Revised Plan to 5 Willow Road Application to construct: Swimming Pool/spa with patio, fencing, and roofed over rear patio with outdoor kitchen.

RE: 5 Willow Road
Village of Woodsburgh,
Drainage review No.3
NCTM: 41-39-767
R&M No. 2022-065

R&M Engineering has reviewed the revised Grading & Drainage Plan for the subject parcel as prepared by Northcoast Civil Land Surveying and Civil Engineering, dated 4/20/2022, last revised 8/25/2022 and find the drainage calculations have been revised to provide for a 5-inch rainfall which includes the 6,000-square foot tributary lawn area. The stormwater runoff generated from the proposed impervious and tributary pervious area is captured and conveyed to six (6)-10-foot diameter by 4-foot effective depth drywells with a storage capacity of 1,644 cubic feet with the bottom of structure more than 4 feet above groundwater. The proposed improvements also incorporate permeable pavers thereby decreasing the impervious coverage and to capture runoff from the patio. The area beneath the patio is capable of storing 848.2 cubic feet of stormwater in the 12-inch-deep stone void, the combined storage is equivalent to 2,492.2 c.f. and exceeds the required 2,

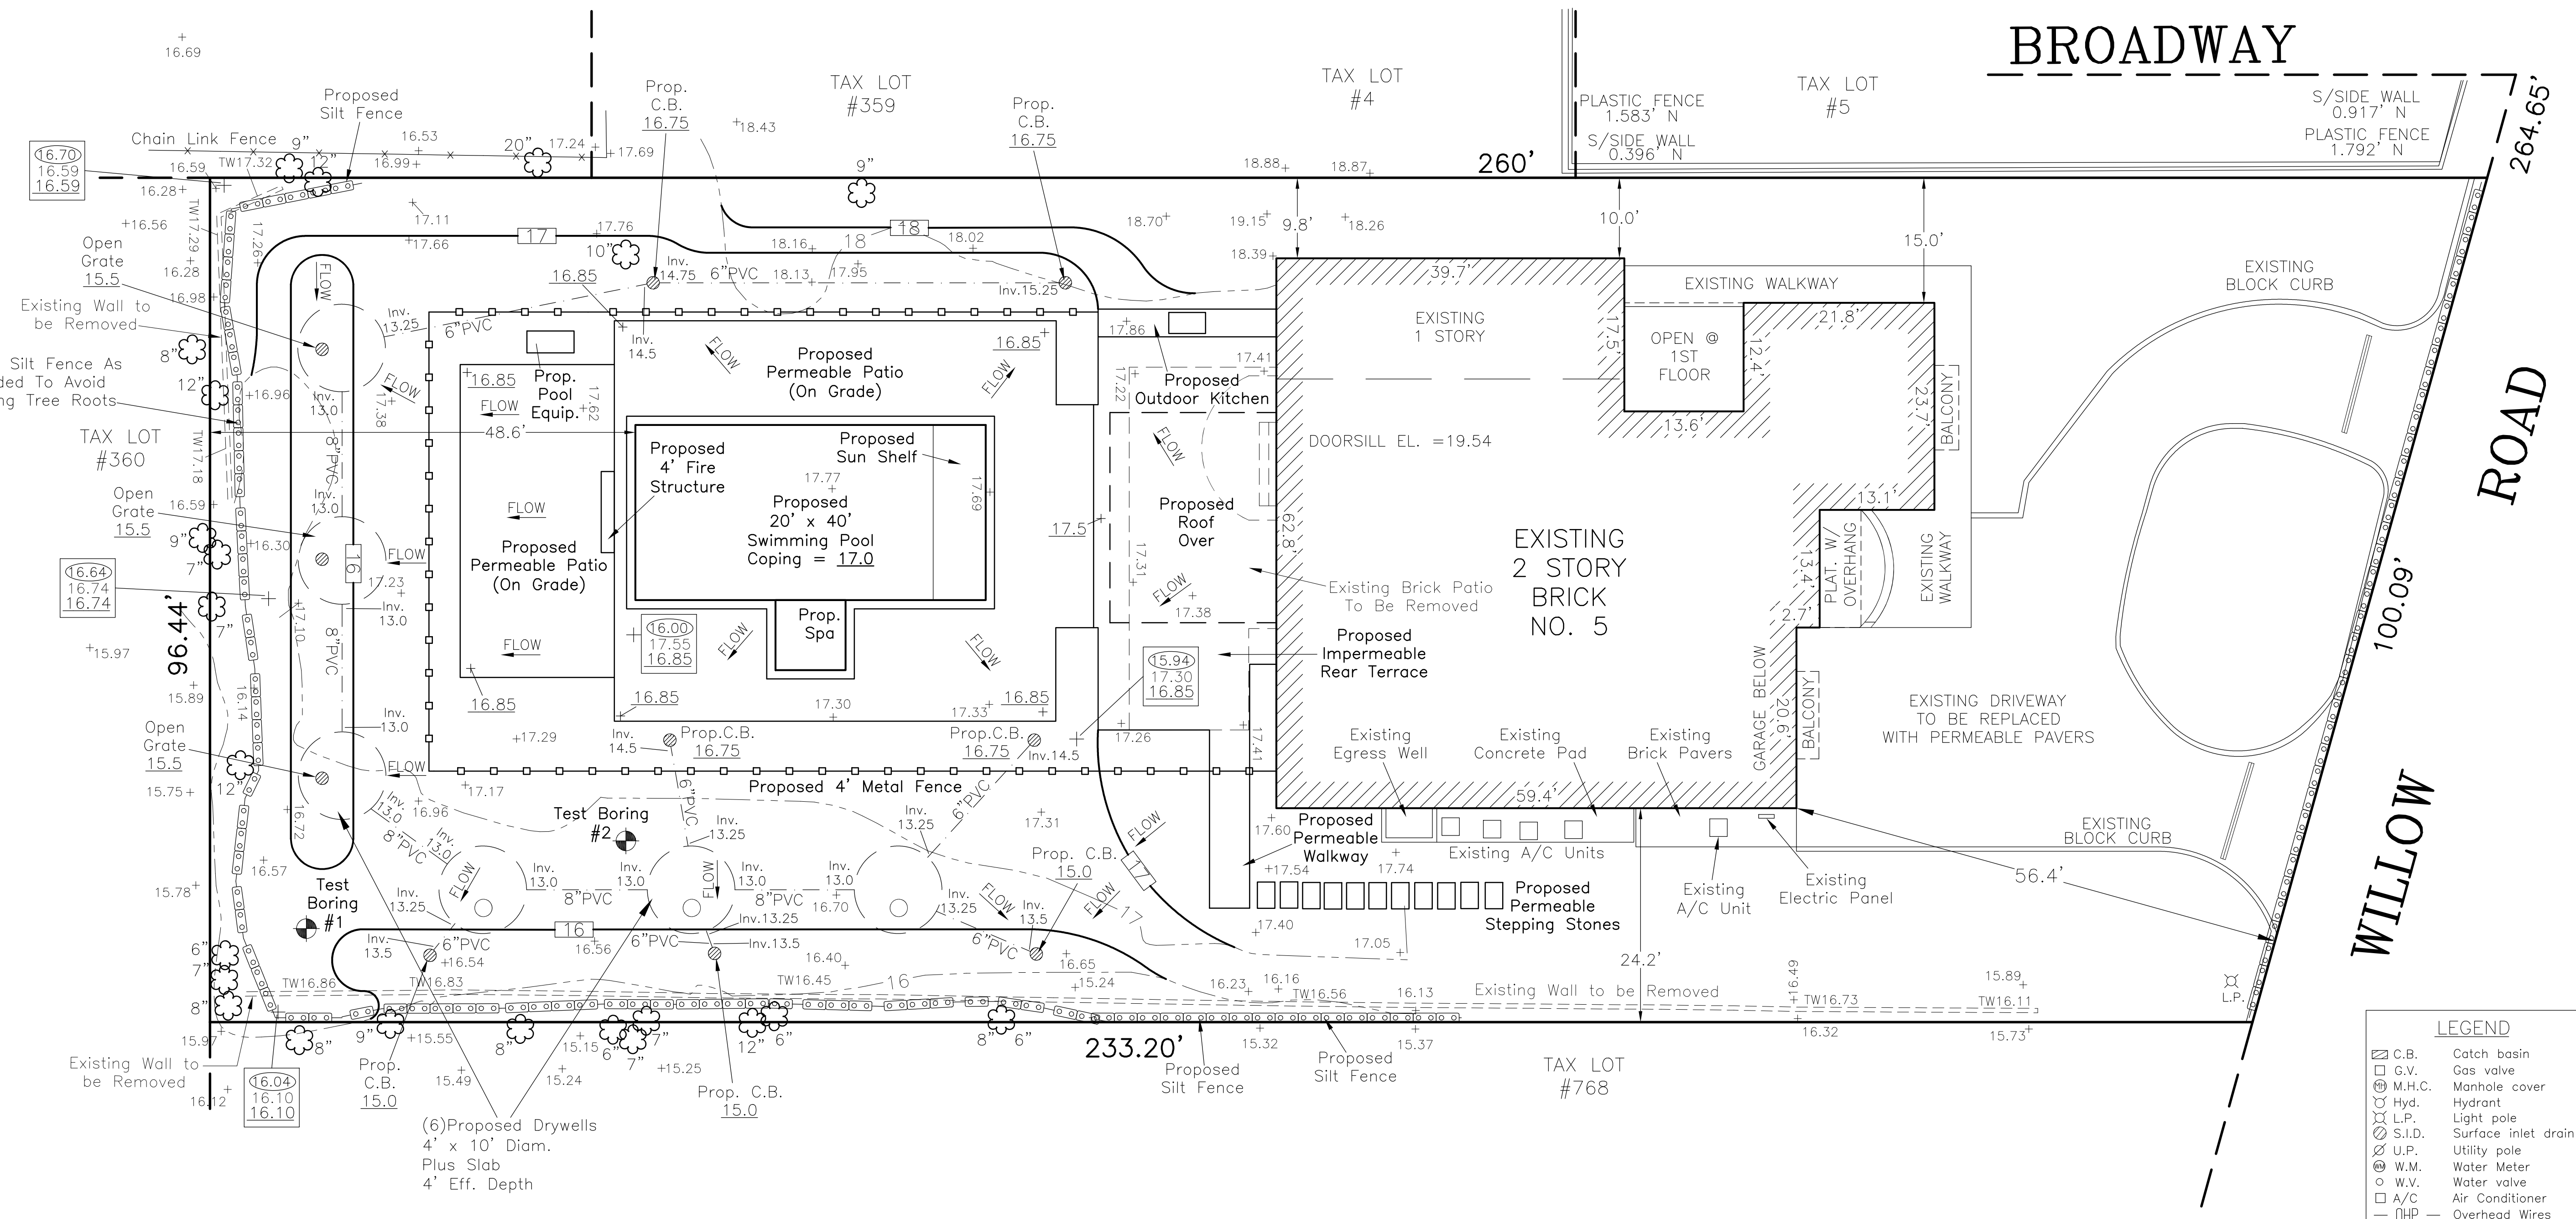
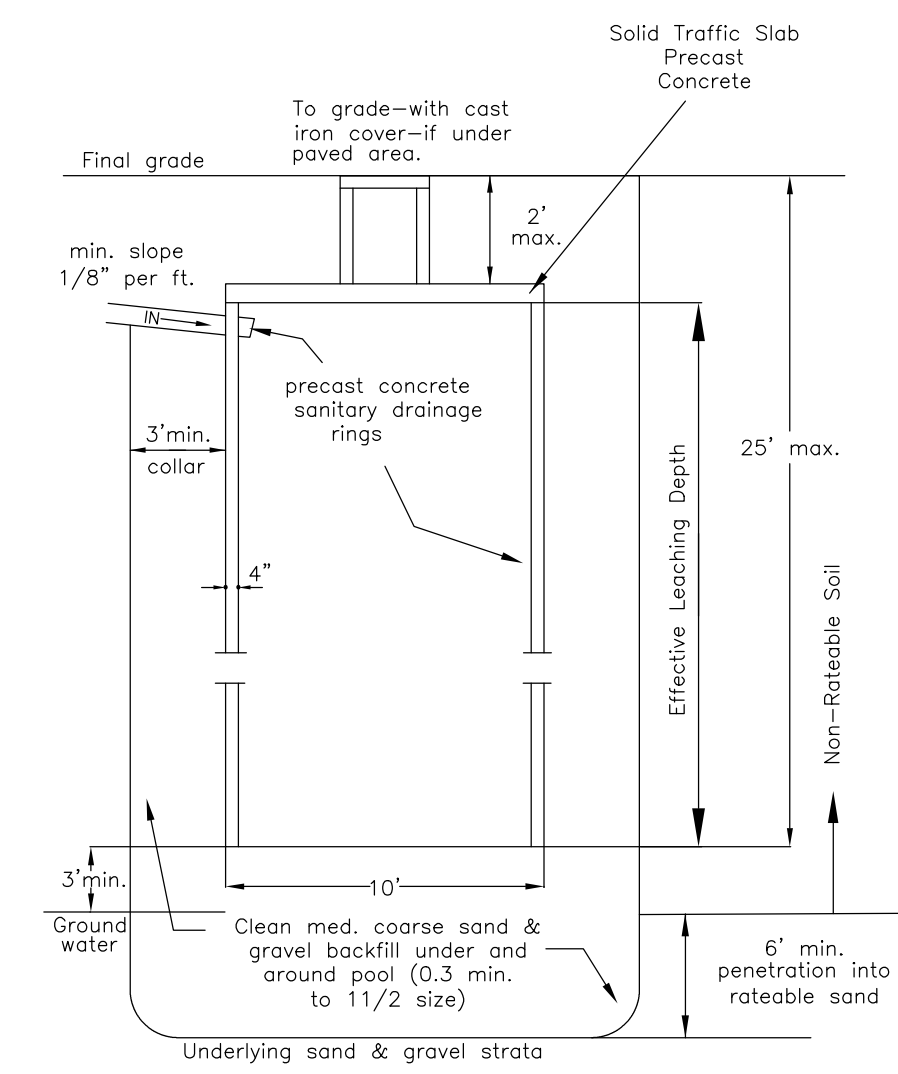
In addition, the proposed grading incorporates drainage swales and a +/- 6-inch berm to convey, capture and store stormwater runoff and maintain it on-site without disturbance to adjoining properties. Based on the findings above, it is our professional opinion that the improvements are in compliance with the Village Code as set forth within § 150-47- Swimming Pools, Article IX- Erosion and Sediment Control and the Village of Woodsburgh Swimming Pool permit application requirements for less than 1-acre of disturbance. The proposed catch basins and drainage system will contain the stormwater on-site and rainfall runoff will not leave the property in the event of a 10 year, -24- hour storm occurrence and thereby will have no adverse effect on adjoining properties.
